EPSON PRODUCT SUPPORT BULLETIN

Date:	04/20/2009	Originator:	JAM
PSB #:	PSB.2009.06.001	Authorization:	<i>Kas</i>
Reference:	TI 09-05e Rev. A/B	Total Pages:	5
Product(s):	PowerLite 735c / Cinema 500 / 737c / 745c / 755c / 765c / 830p / 835p / 1705c / 1715c / 6100i / 6110i / 7800p / 7850p / 7900NL / 8300i / 8300i with EasyMP.net module / 9300NL / 1815p / 1825 / 822p / 83c / 822+ / 83+ / G5000 / Pro G5150 / Pro G5350 / Pro G5200W / 1725 / 1735W / 400W / 410W / 84 / 85 / 825 / 826W PowerLite 61p / 81p / 82c / 821p / 1810 / 260d (Latin America) / 280d (Latin America) with TCP/IP to Serial converter		
Subject:	Release of EMP Monitor for Windows version 4.30

Date:	11/13/2007	Originator:	AP
PSB #:	PSB.2007.11.005A	Authorization:	Kas
Reference:	TI 07-63e, Rev. A	Total Pages:	3
Product(s):	Epson EMP Monitor		
Subject:	EMP Monitor Version 4.21 Release

EMP Monitor V4.30

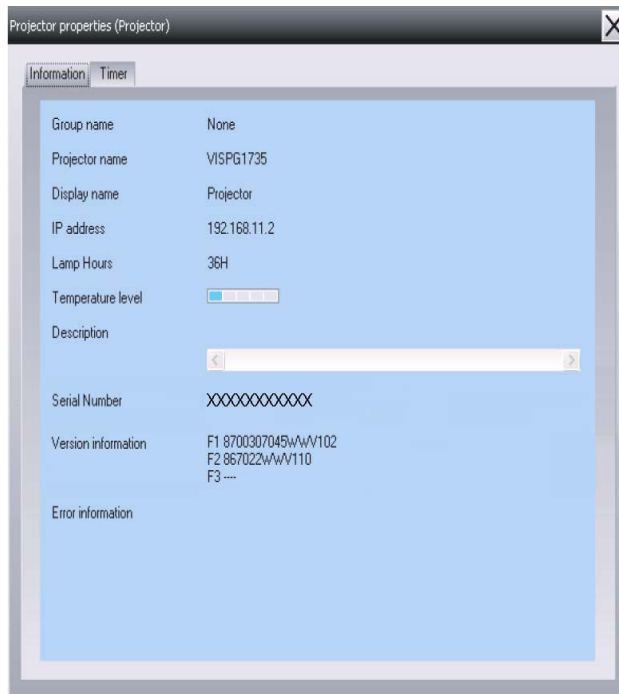
(2) Addition of Input Source (Only PowerLite 84 / 85 / 825 / 826W)
Previous version of EMP Monitor included USB Display, USB and LAN as one source: EasyMP.

The input source buttons for USB display, USB, and LAN are available as separate input sources as shown below:

- Old version - EMP Monitor V4.22

- New version - EMP Monitor V4.30
